SLF 7.62HP - change of lock and release lever

the below listed articles will be supplied in a modified revision. Please pass this product information on to your employees and, if needed, to your customers. All modifications are performed for reasons of product improvements.

Old version	New version
-------------	-------------

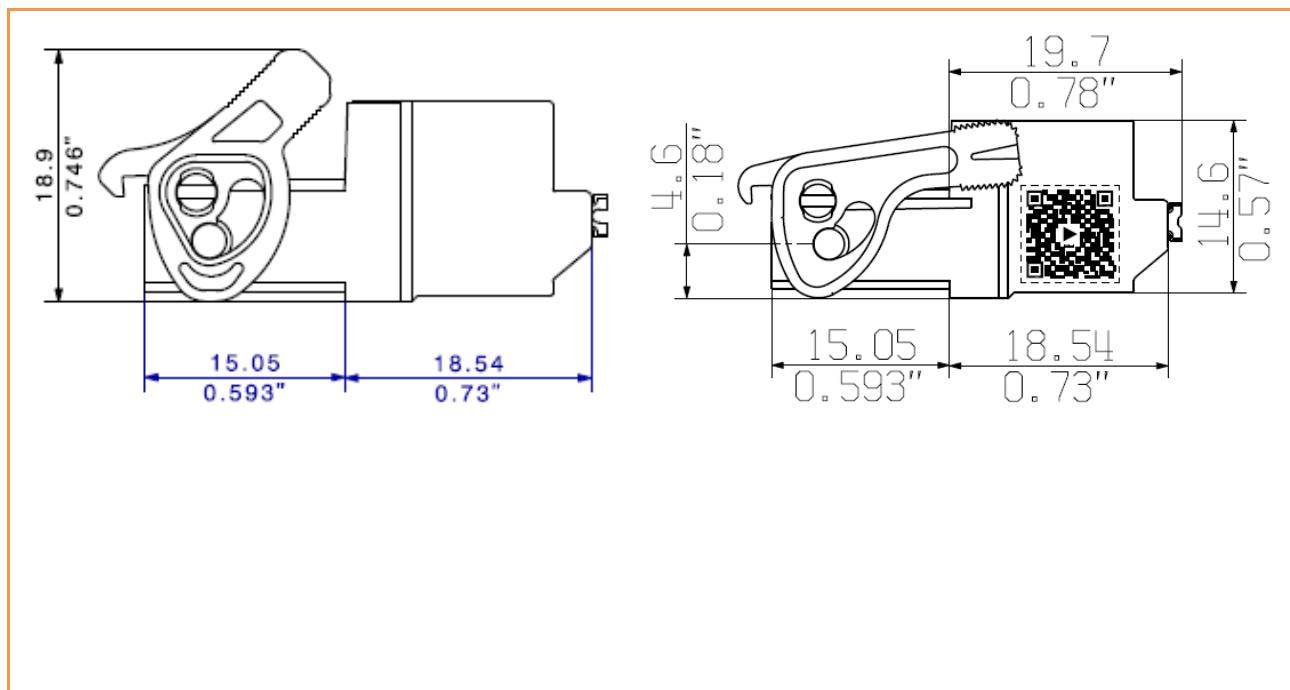
Compared with the previous the new lock & release lever is designed much flatter. Due to this compact design more connectors can be placed side by side on the front panel.

- The lock & release lever latches automatically during insertion (called auto-lock-function). Subsequent locking after plugging is not necessary.
- Higher leverage makes the disconnection of the male plug easier.
- Improved handling in confined spaces by a longer lever.
- When the lever is actuated, the female connector is released more gently from the component assembly. This is important in case of extreme ambient temperatures.
- When the lock & release lever is locked, the reinforced latching-hock increases the maximum pull-out force and avoids an inadvertent disconnection of the male plug
